Amendment Planning Application - Reg. Ref. SD21A/0175

Additional Information - Architectural Design Statement

Fig. 1. – Permitted Development – different colours indicate plots in separate private ownership

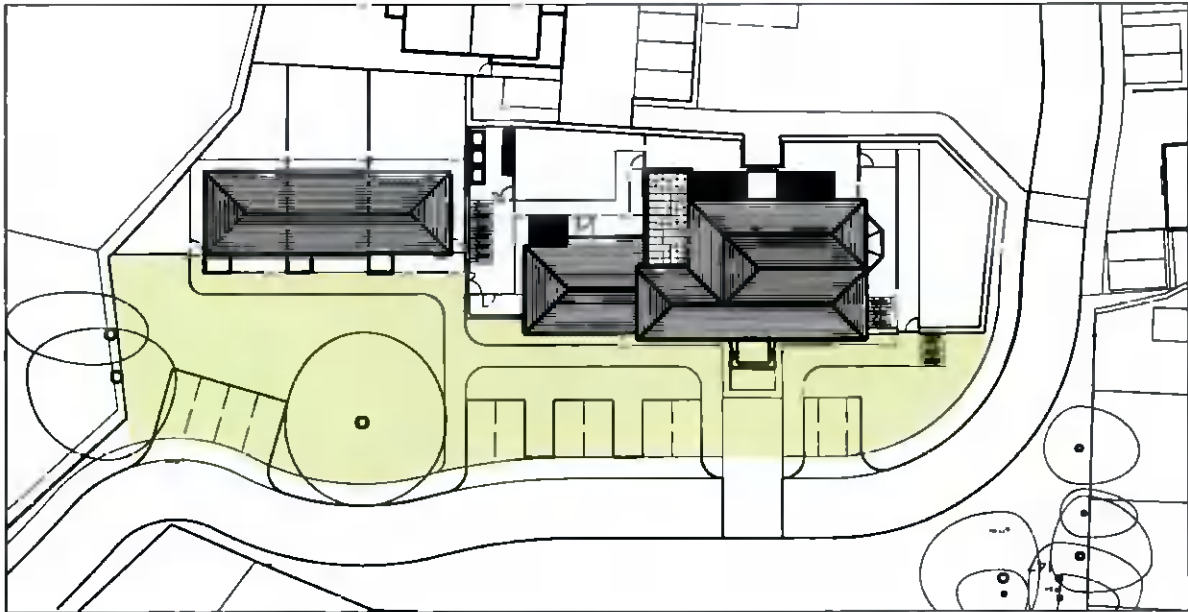
Figures 1-4 below outline the positive impact the proposed revisions to the permitted development will have on the visual impact and landscape setting of the Protected Structure.

Fig. 2. – Proposed Revision – coloured area indicates extent of landscaped open space across the front of the protected structure which will be under the management of a single entity

Fig. 5. – Permitted Development – ground floor demolition

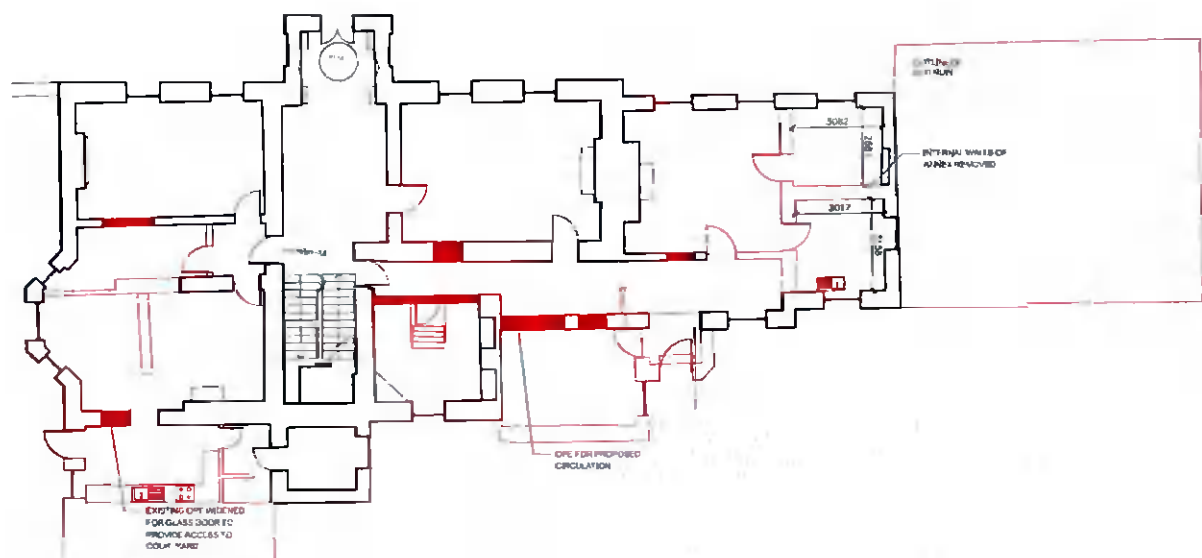
Figures 5-10 below demonstrate that the level of fabric removal required to achieve the permitted and proposed revisions are essentially neutral in terms of impact on the protected structure.

Fig. 12. – Permitted Development – rear elevation

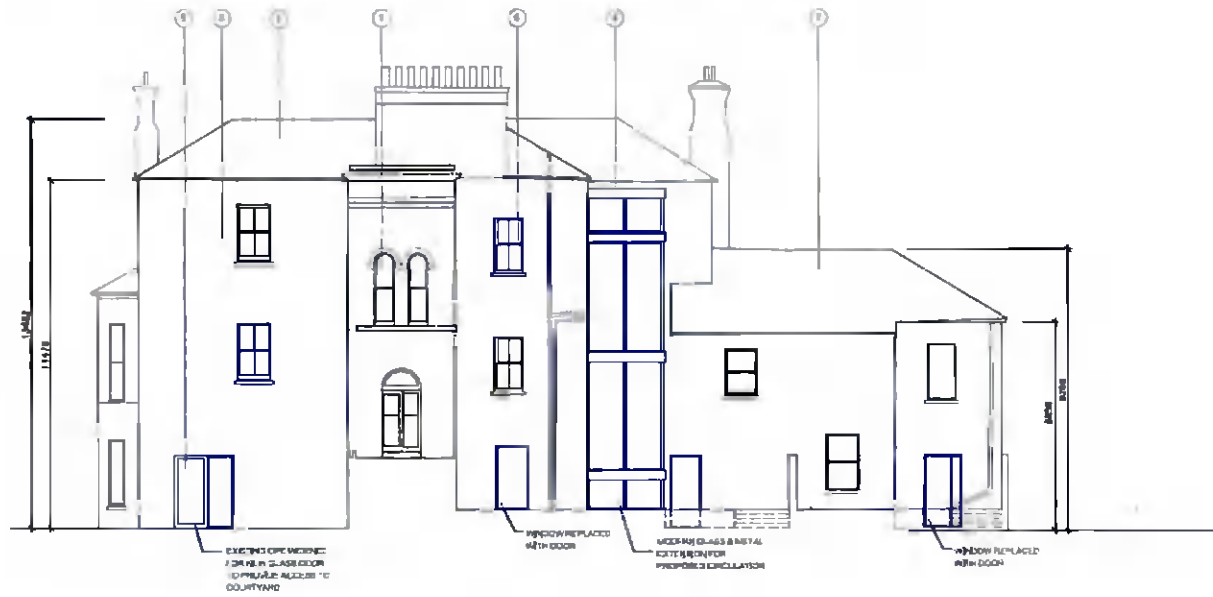
The revision to the permitted rear addition reduces its height with the amended design now set back from the plan of the existing rear return. Windows sizes have been increased to reduce perceived visual massing and proposed material change to vertical charred timber cladding serves to compliment the addition with the verticality and materiality of the proposed balcony structures.

Figures 12 -14 below show the evolution of the rear elevation.
